Product Type: STEINER 430

Bulletin No: JC-020-07

Service Bulletin

Installing a heat shield in the 430-33G

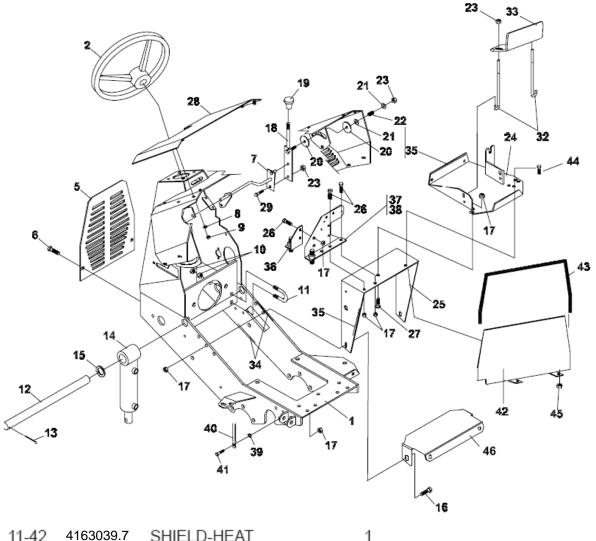
Complaints of heat circulating under the dash causing the controls to get hot

Install a heat shield between the engine and dash

(1)	4163039.7	Heat Shiel
(2.97 FT)	56-068	Trim
(2)	64139-04	Bolt
(2)	64141-2	Nut
